DER is preparing a report to provide basis for the following:

Rib Installation - Riveting Procedure

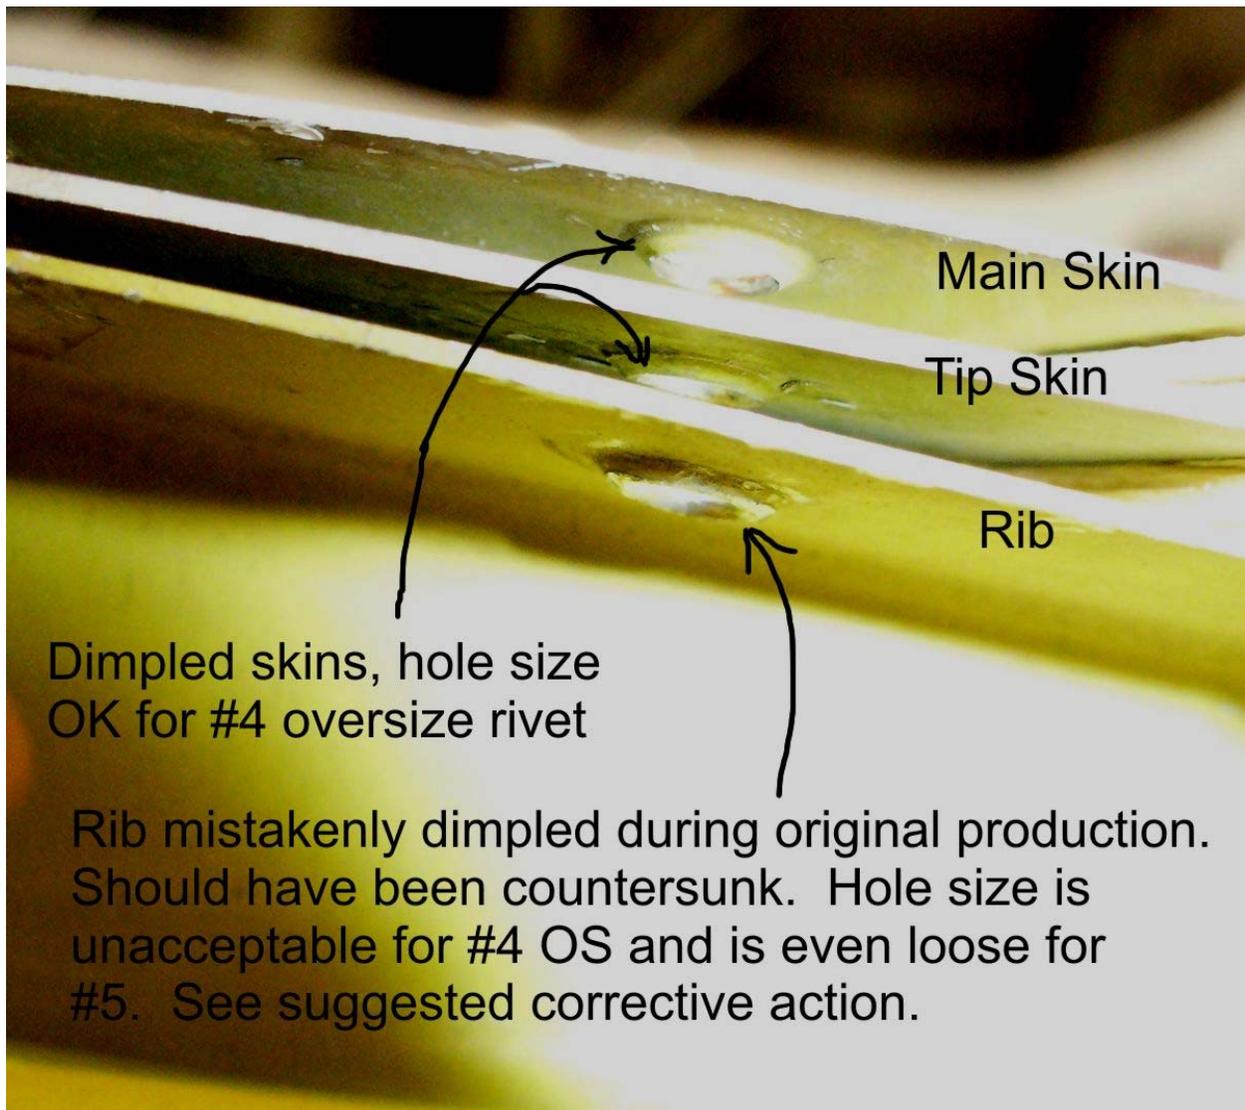
Some, maybe most, of the ribs were not properly originally installed. The assembly procedures called for the two skins to be dimpled, but the ribs to be countersunk. In fact, it appears some ribs were dimpled along with the skins causing the rivet hole in the rib to be already very loose for even a #5 rivet while the skins are probably still good for a #4 oversize, see picture.

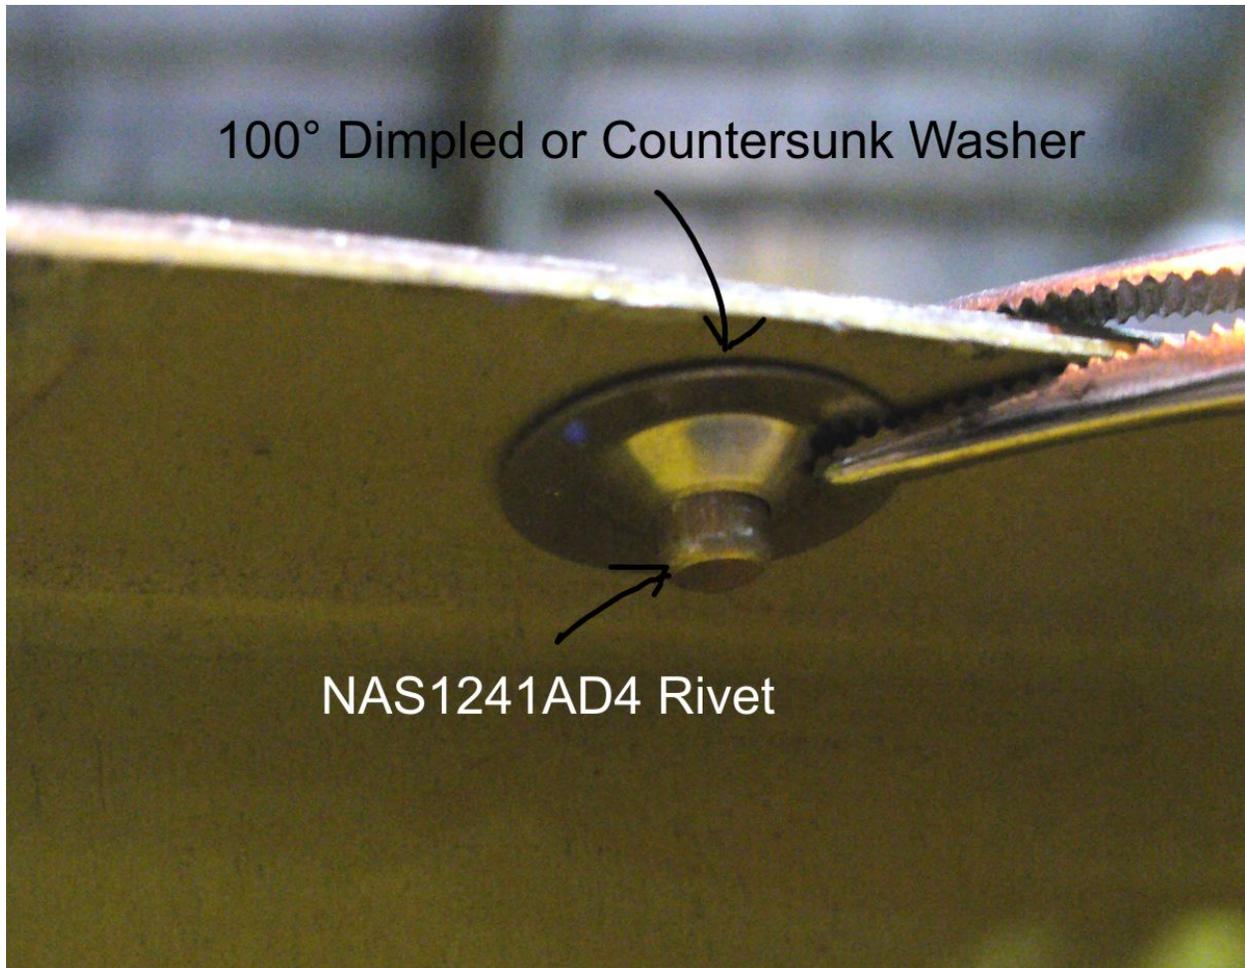
The Gulfstream repair corrective action procedures allow for recovery of cracked or compromised dimples by dimpling an AN960 (-6 in this case) and using it as a backup. DER prefers using a CSK washer, see picture, because of the larger footprint, and recommends structural adhesive in the buildup to fill the gaps caused

by the oversized hole in the rib. While a NAS1169DD6 aluminum CSK would be preferable from a galvanic perspective, we have found that the A3236-SS-012 stainless CSK's from Aircraft Spruce are a much better fit to the NAS1241AD4 rivets than either the DD6 CSK's or dimpled AN960's.
